2010-COA-583 (LS)	INDIANAPOLIS HISTORIC PRESERVATION COMMISSION STAFF REPORT	Hearing Date APRIL 6, 2011
621 VERMONT ST. AKA. 619 E. VERMONT PL LOCKERBIE SQUARE		Continued for 2 months from: Feb. 2, 2011
Applicant SCOTT PERKINS, BLACKLINE mailing address: 1043 Virginia Avenue, Studio 211 Indianapolis, IN 46203		
Owner: KEN ADAMS, ADAMS INVESTMENTS LLC		Center Township Council District: 15
CASE		Doris Minton McNeil
IHPC COA: 2010-COA-583 (LS) To retain all windows installed without approval		
STAFF RECOMMENDATION: Continue to May 4, 2011

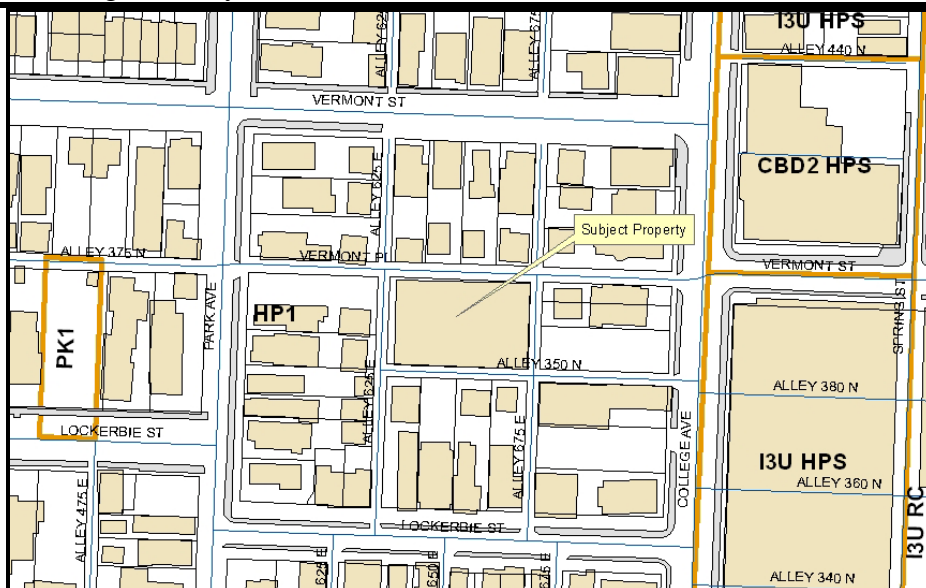
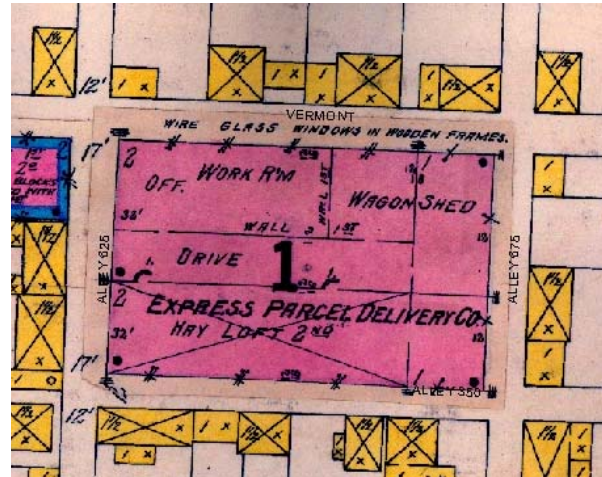
The previous photos display the following problems with the new aluminum slider windows:

- The steel windows were all on the same plane, while the slider replacement windows have movable sections that are on different planes.
- The plane differentiation is more similar to a modern sliding glass door than to a traditional double-hung window, which accentuates the visual incongruity of these windows.

- The use of a transom with wide separation bar is at significantly dissimilar to the original configuration of the steel windows.
- The windows include grids sandwiched within the insulated glass, which gives a different visual effect than the true divided lites of the steel windows.

- The grids in the new windows create “panes” that are oriented horizontally, while the panes on the steel windows were oriented vertically.
- Exterior screens on the new slider windows emphasize the window in two planes and alter the color and appearance significantly from the original aesthetic.

- As a material, the aluminum on the new windows is an appropriate replacement for steel. However the dimensional differences are greater than would be desired.

1. Find a more appropriate replacement window. Staff has identified one option that may be more appropriate, but the owner must explore that option and others that may exist.
2. Determine if some of the windows have less impact on the overall character of the building and consider allowing them to remain, focusing limited resources on those windows that will make the biggest impact on overall character.
3. Consider phasing the replacement to spread out the economic impact.
4. Consider replacing windows when apartments become empty, to reduce the economic impact.
